ARCHITECTURAL REVIEW BOARD REGULAR MEETING AGENDA

June 11, 2026

STAFF REPORT

DATE: June 11, 2026
TO: Architectural Review Board
FROM: Renee Burton, Division Director of Planning
RE: Certificate of Appropriateness PZ25-00583, filed by Justin Williams, for the installation of a new roof at Parcel 20119 (507 Holbrook Avenue).

1 NORTH ELEVATION
Scale: 3/16" = 1'-0"

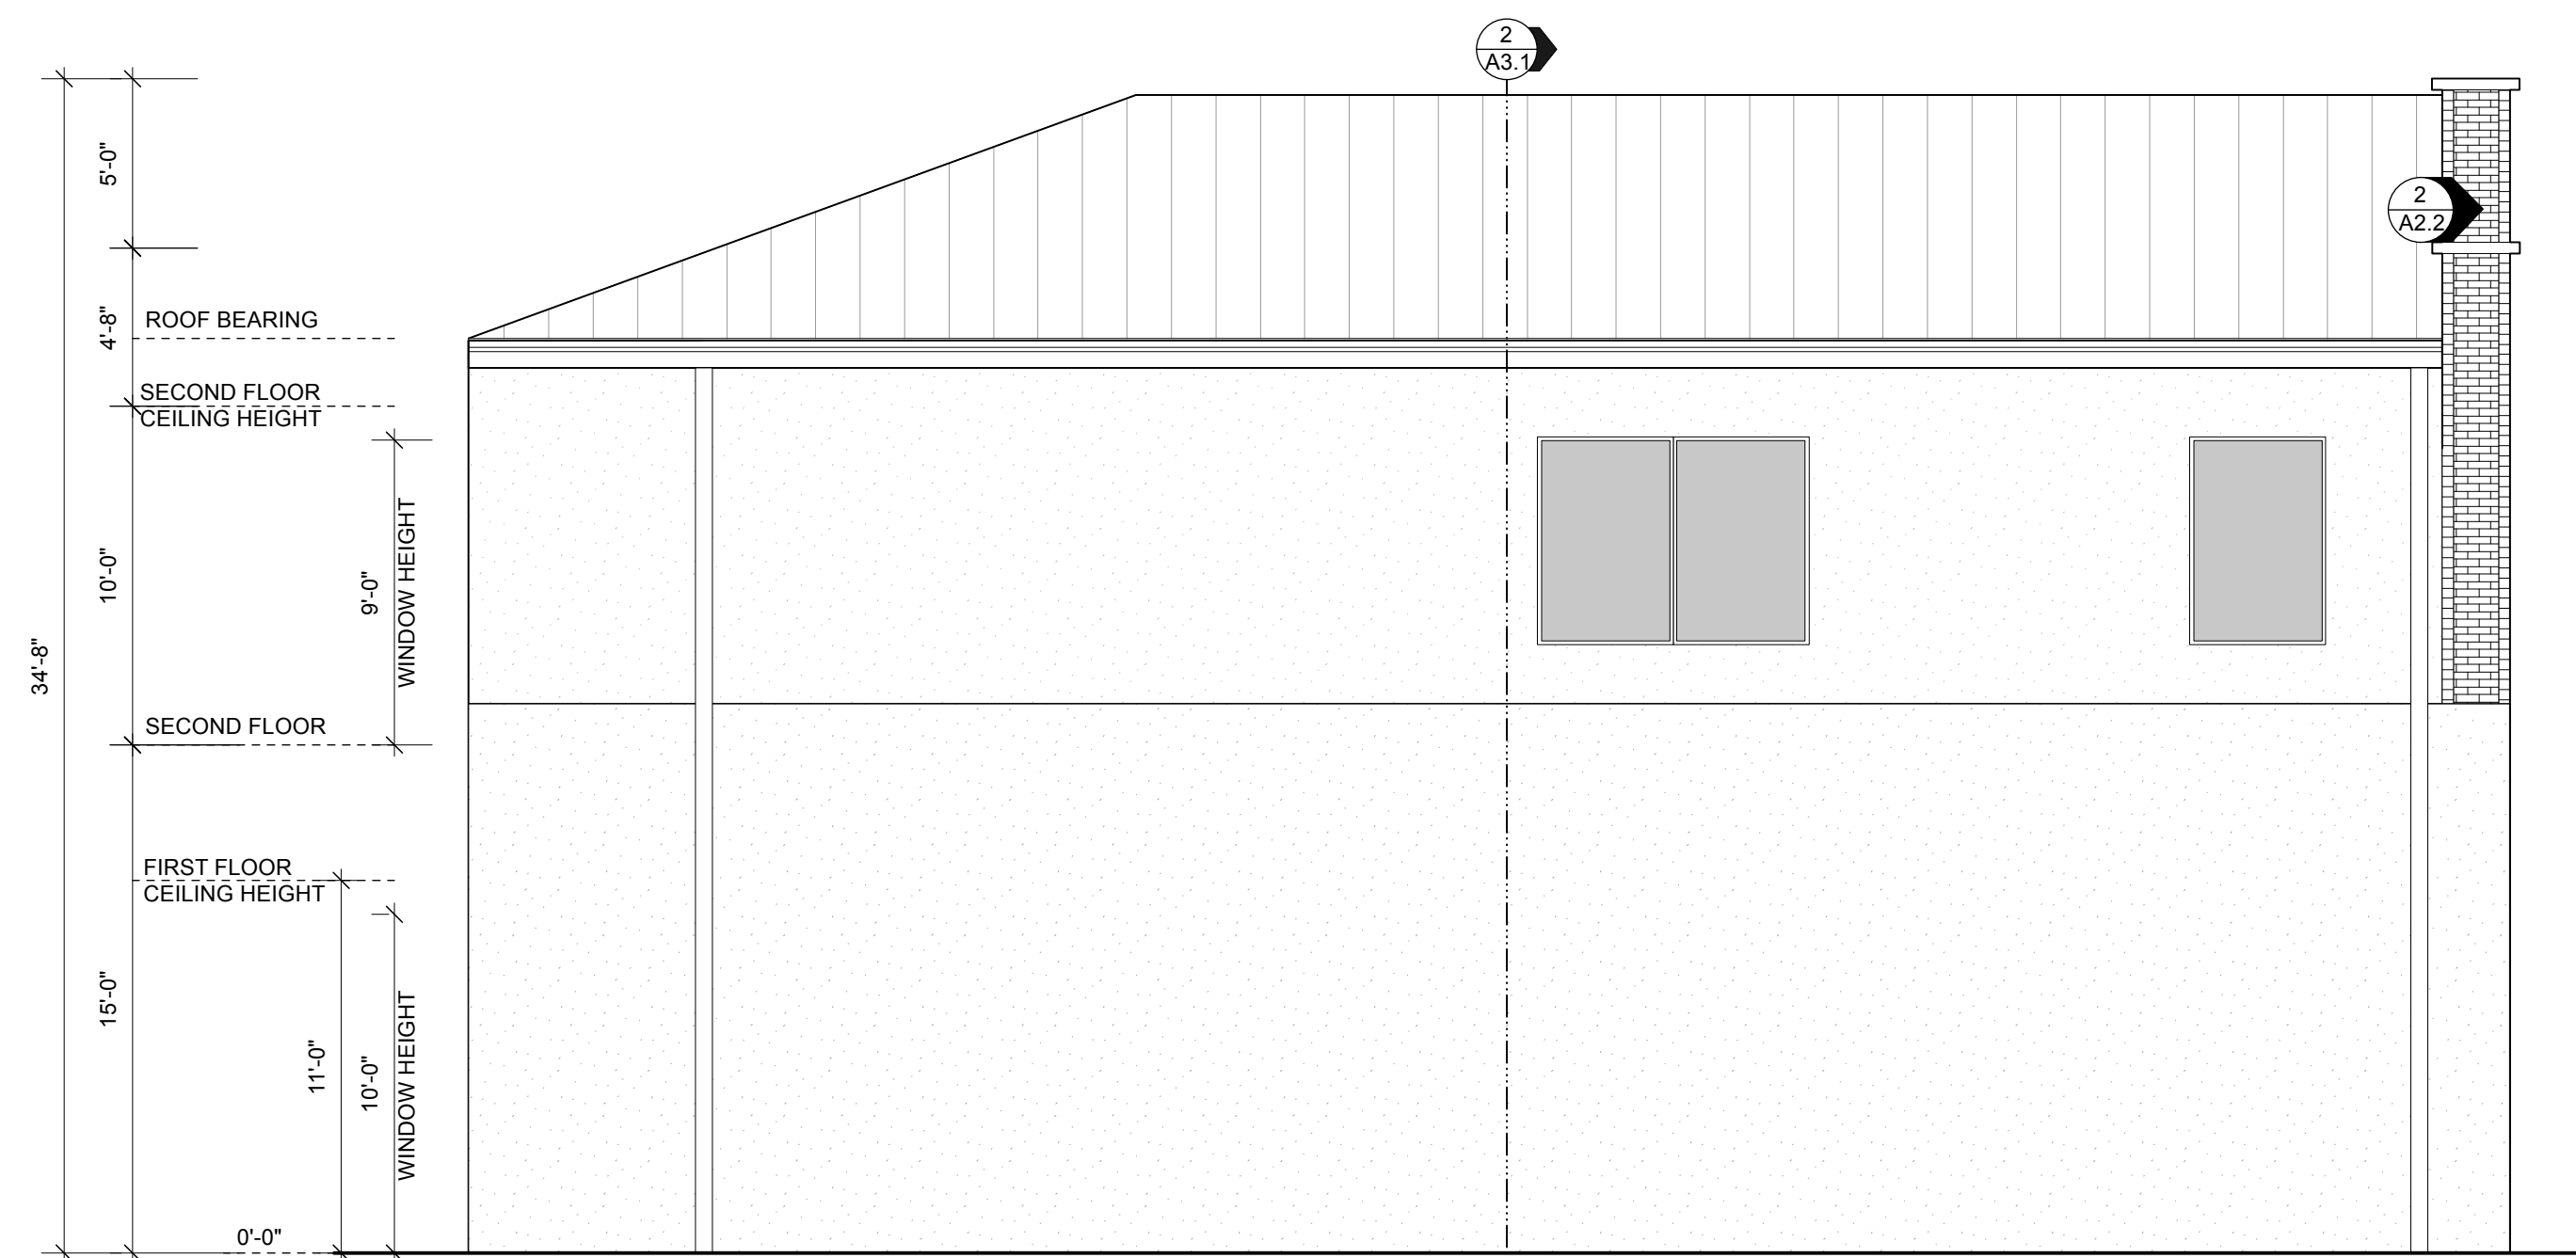
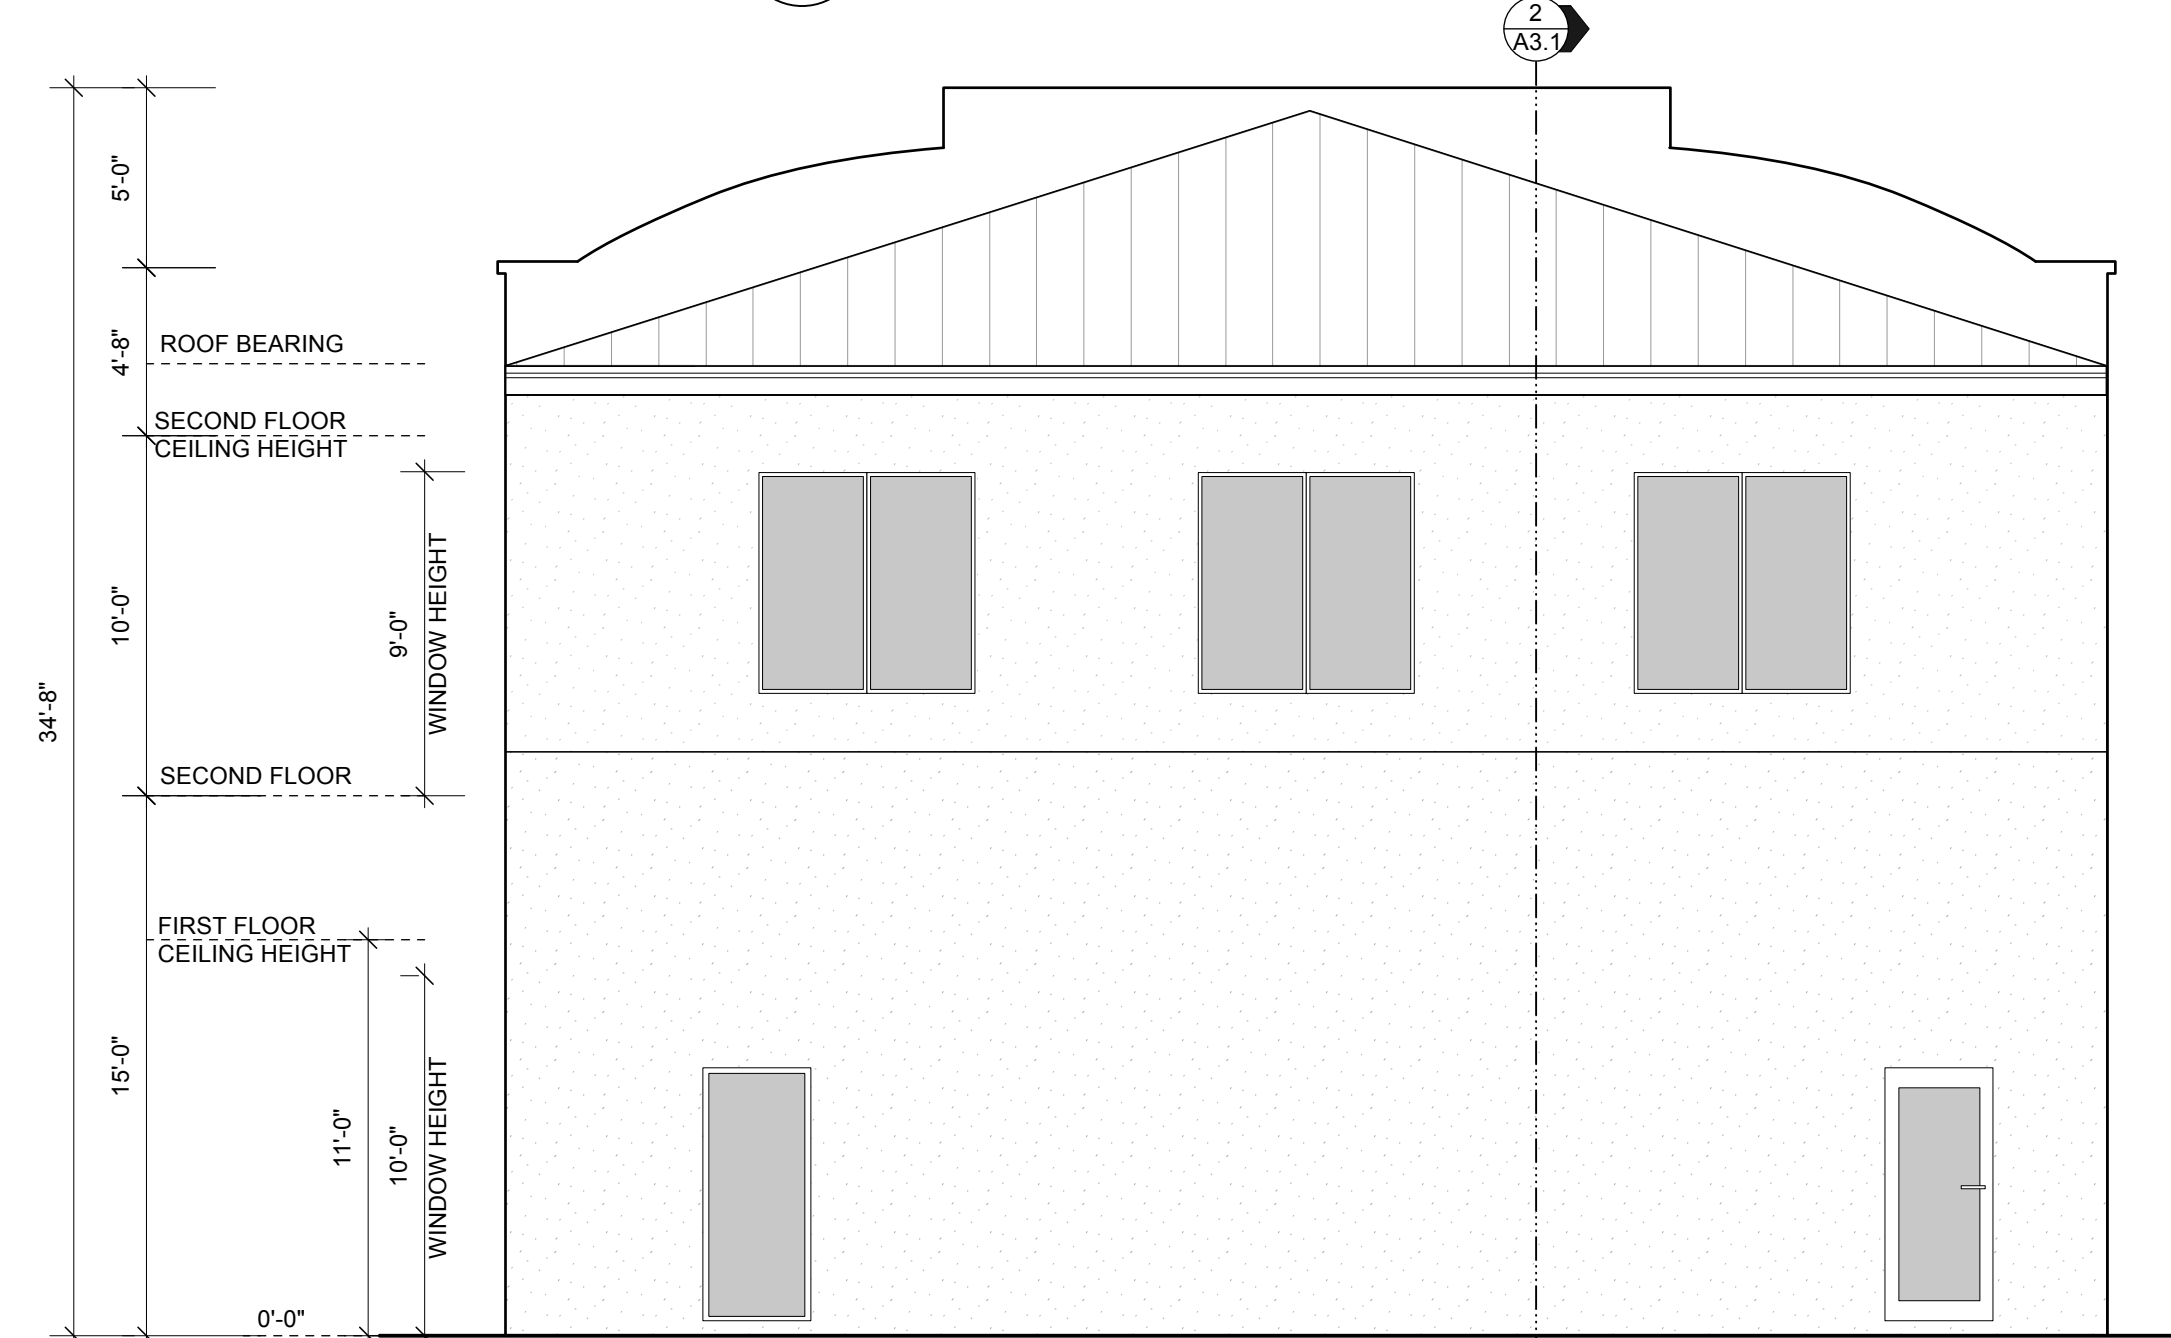
the previous application. Updates to the design include removal of the awning, building moniker, prohibited materials, and historically incorrect window style. Staff's concerns remain in place regarding the proposed signage and encourage the Board to ensure it is attached to the building and not an inlay of the building in comparable material. Staff also recommends the applicant provide more details regarding the windows and entrance door materials, as well as the arch of windows above the entrance door.

Planning staff recommends approval of Certificate of Appropriateness PZ26-00354, filed by Mark Willard, for the design "Option A" only at Parcel 20310 (211 & 215 North Union Street) with the requirement for further detail of the following items before final approval:
